THE HIGHLINE AT UNION MARKET

320 FLORIDA AVENUE, N.E.
WASHINGTON DC

March 25, 2016
PUD MINOR MODIFICATION FOR PUD 15-01

BUILDING ELEVATION: SOUTH - *PROPOSED*

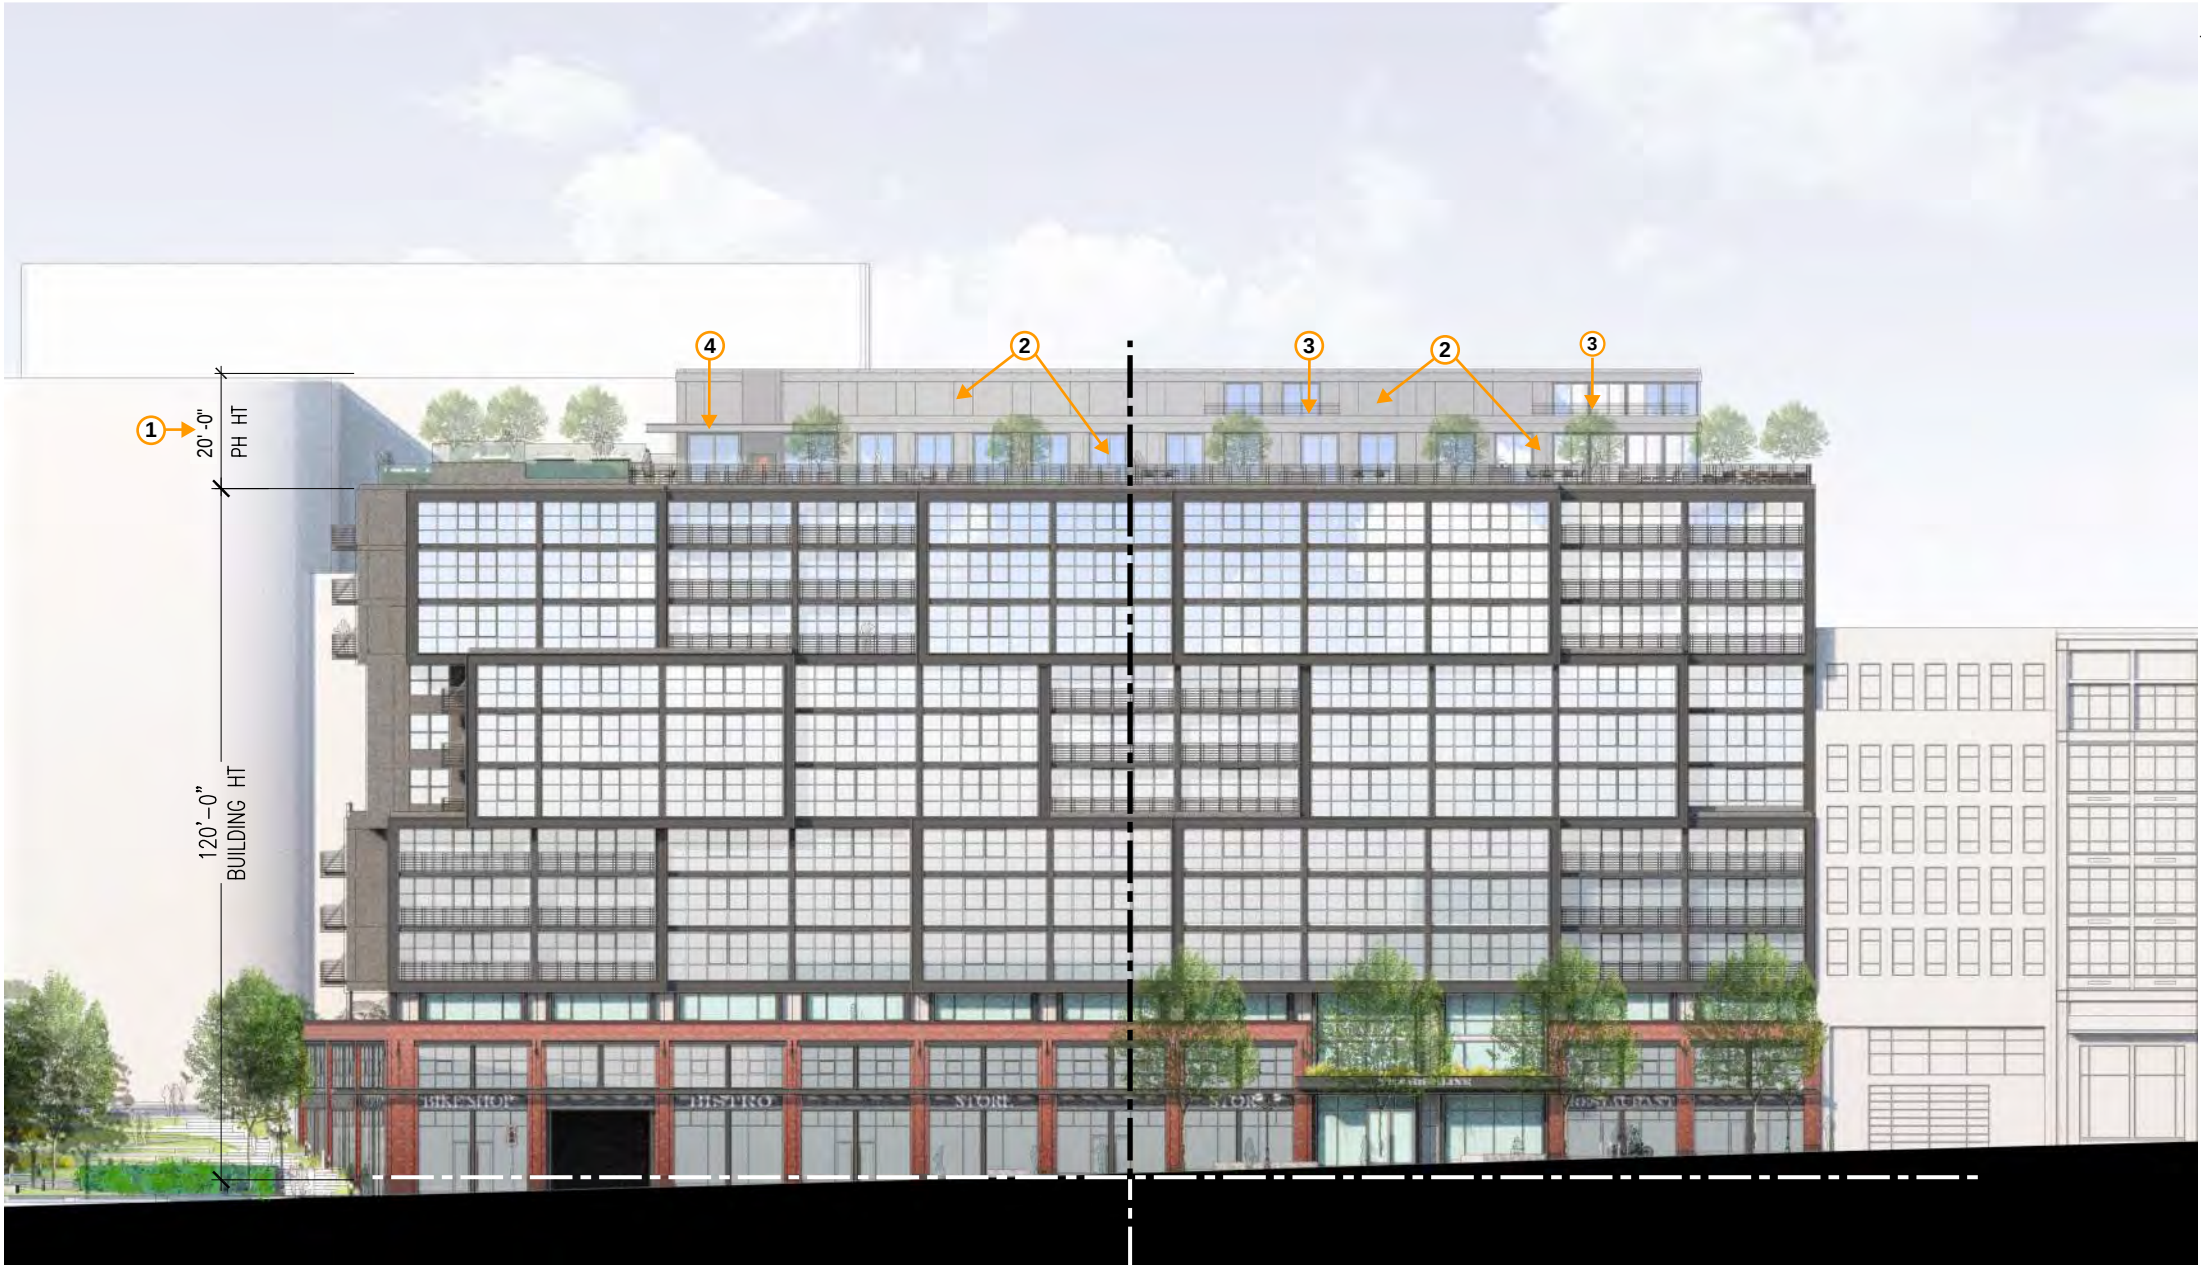
- * CHANGES TO ROOF STRUCTURE TO INCORPORATE ZC ORDER NO. 14-13
- 1. PENTHOUSE HEIGHT NOW 20'
- 2. WINDOW /LOUVER CHANGES
- 3. NEW RAILING (1:1 SETBACK PROVIDED)
- 4. NEW TRELLIS

BUILDING ELEVATION: EAST - *PROPOSED*

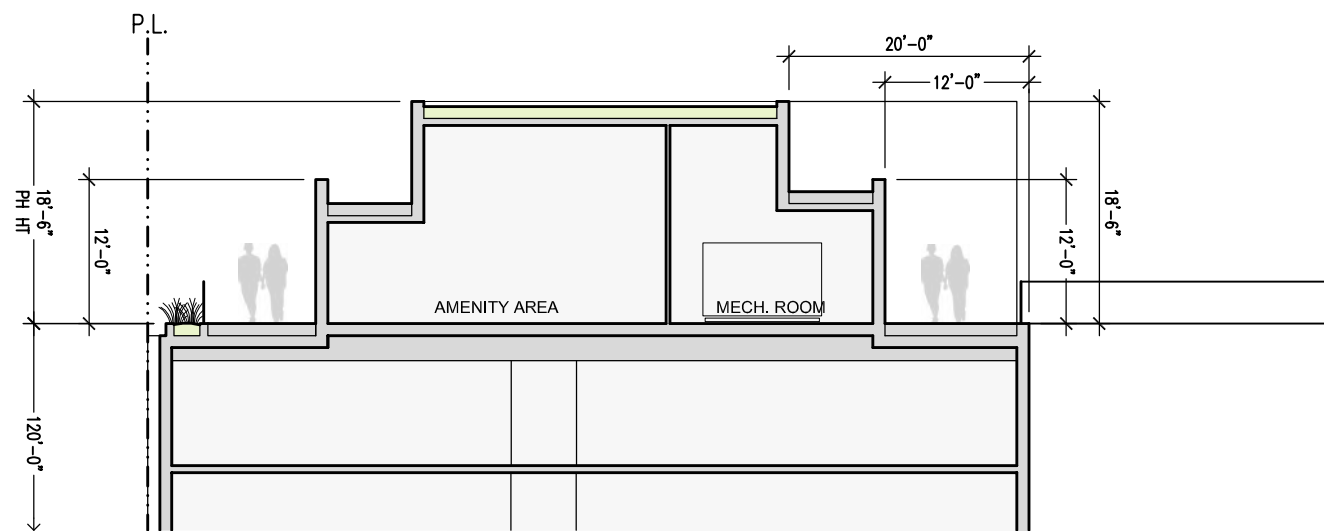
- CHANGES TO ROOF STRUCTURE TO
* INCORPORATE ZC ORDER NO. 14-13
1. PENTHOUSE HEIGHT NOW 20'

2. NEW WINDOWS

3. FACADE DESIGN IMPROVEMENT

ROOFTOP BUILDING SECTIONS - *APPROVED*

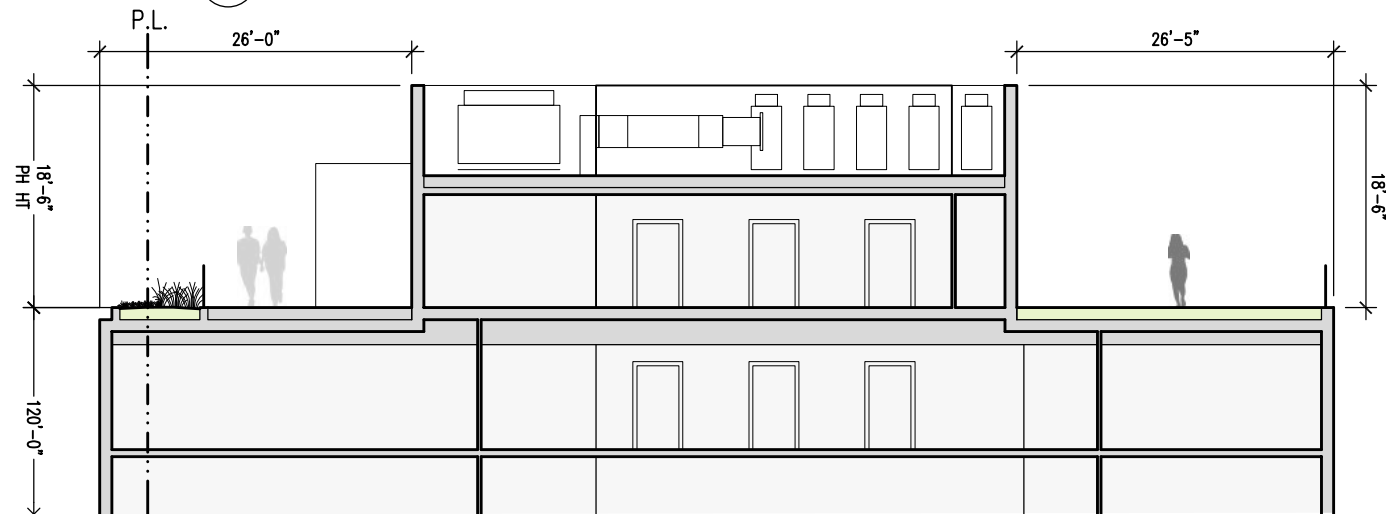
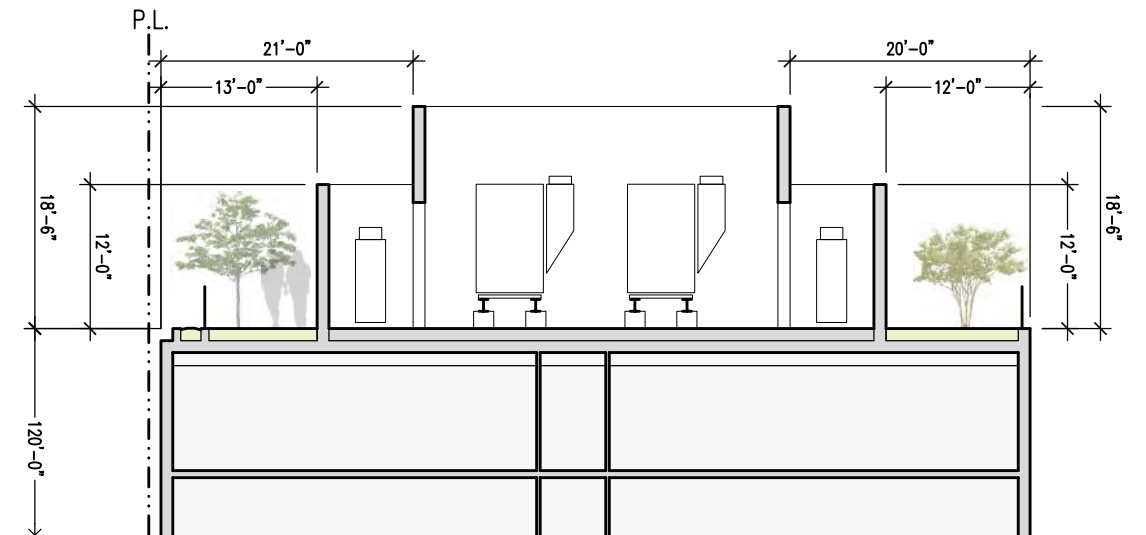
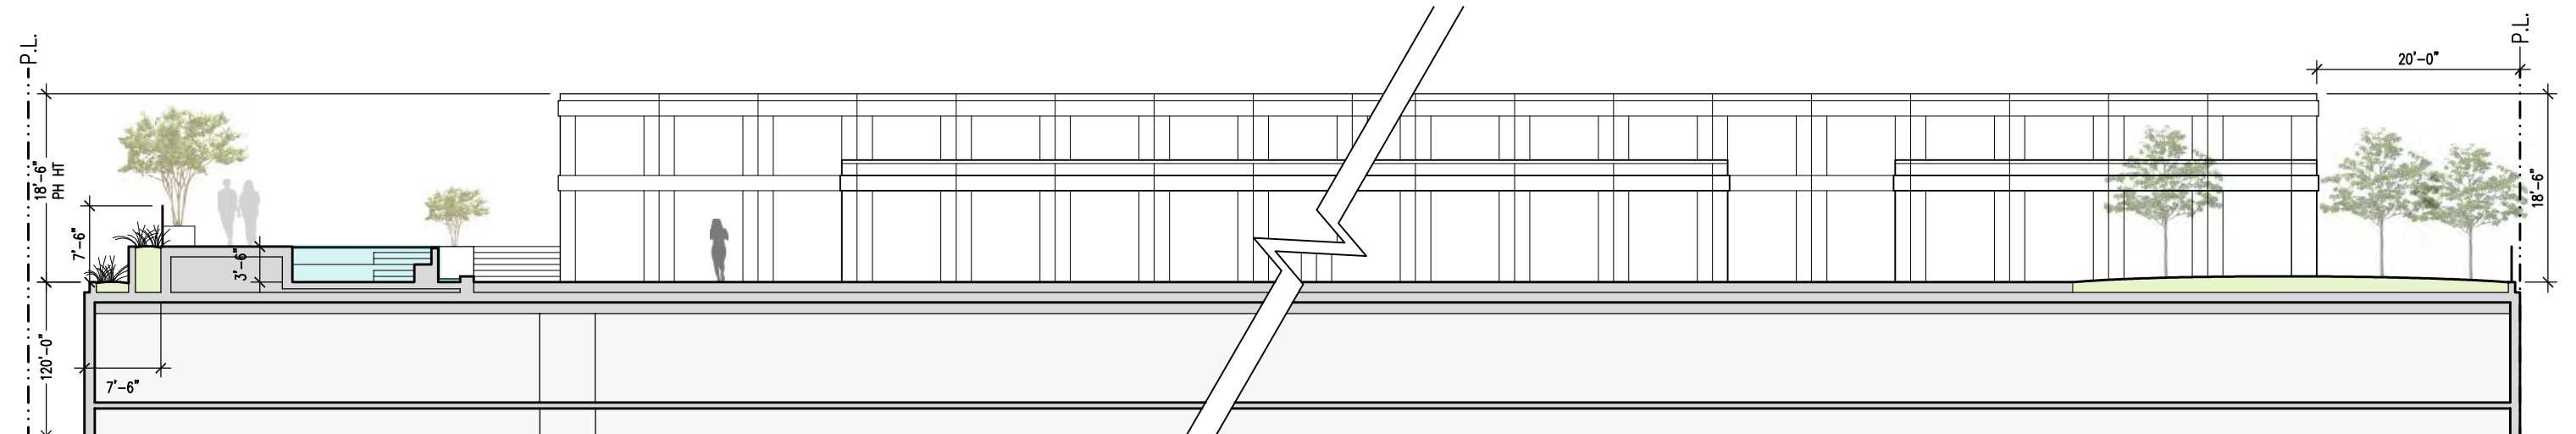
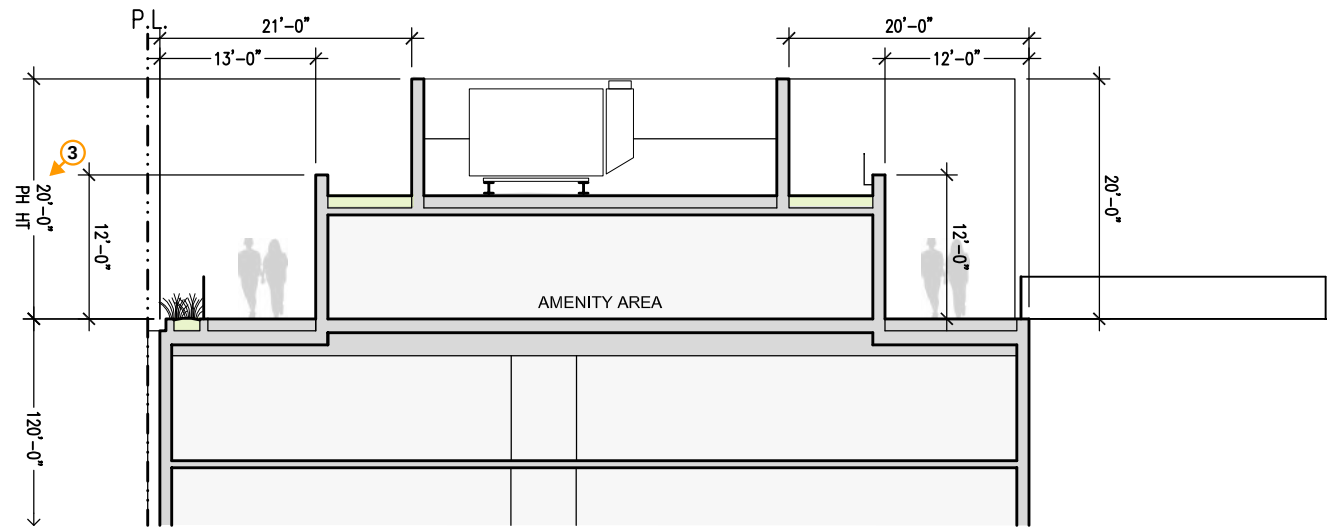
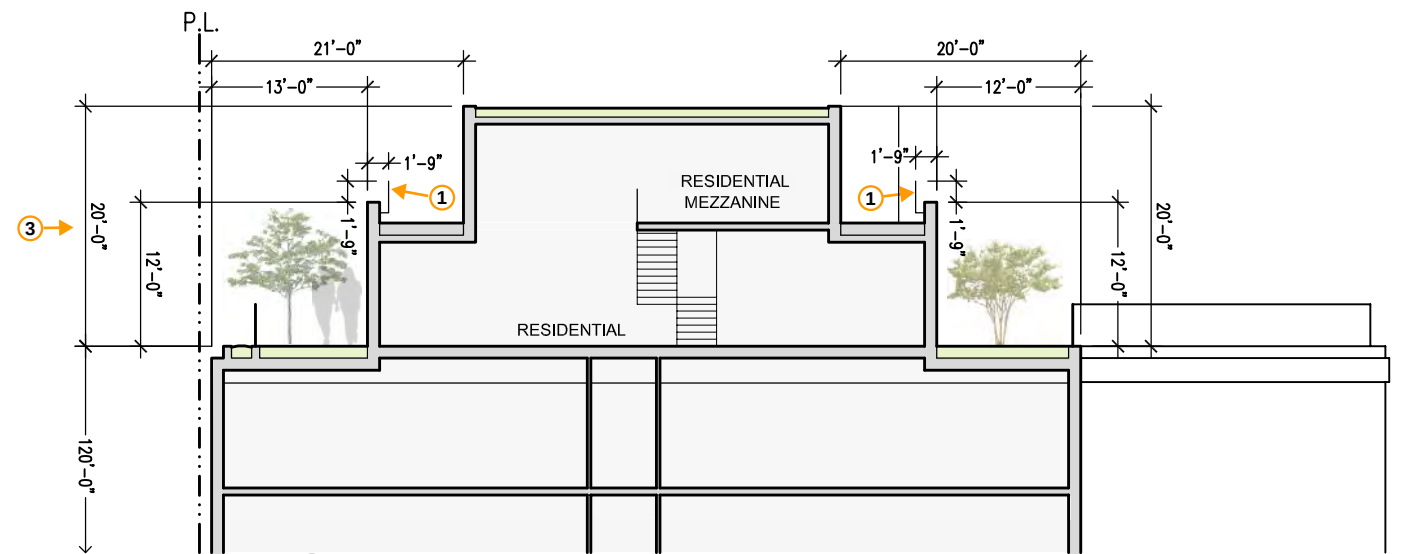
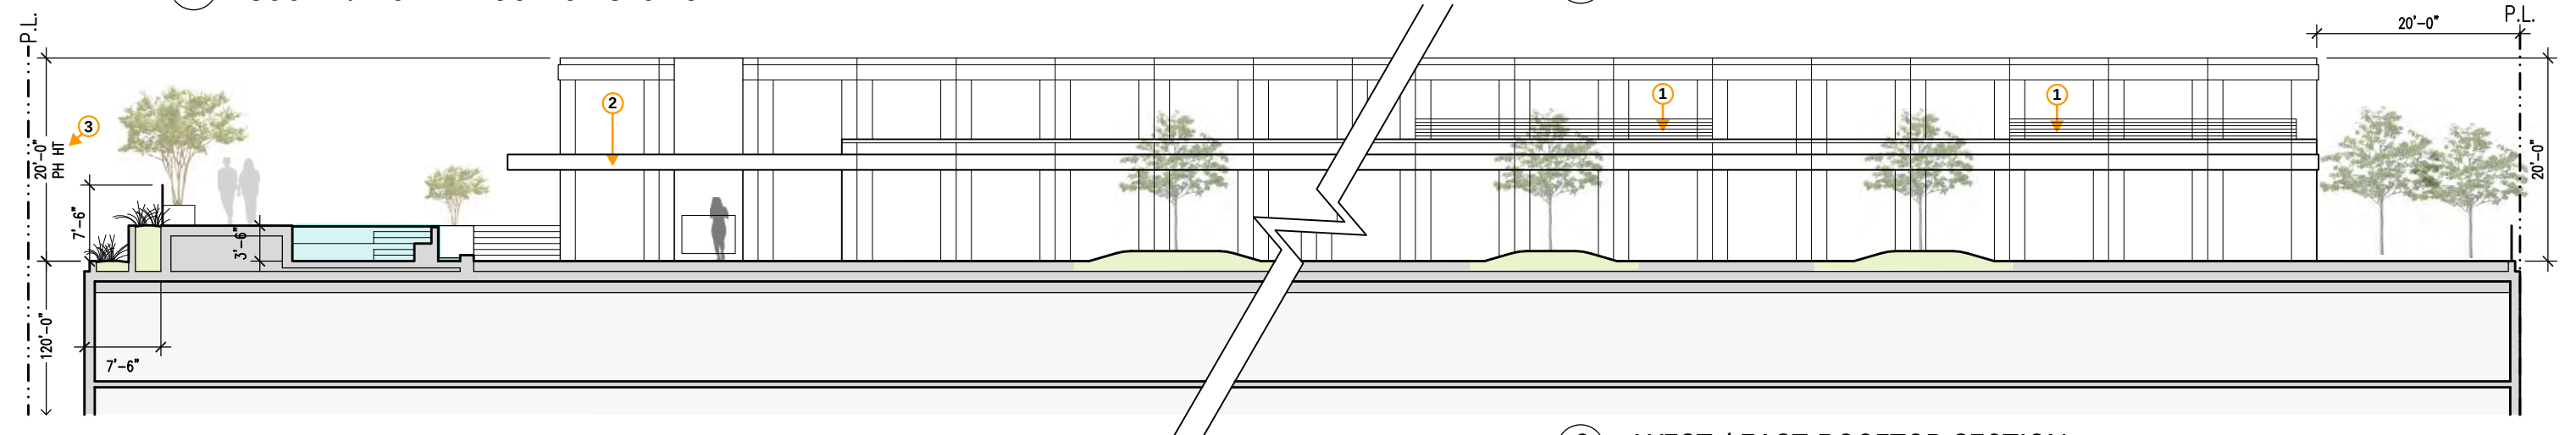
- * CHANGES TO ROOF STRUCTURE TO INCORPORATE ZC ORDER NO. 14-13
- 1. NEW RAILING (1:1 SETBACK PROVIDED)
- 2. NEW TRELLIS
- 3. PENTHOUSE HEIGHT NOW 20'
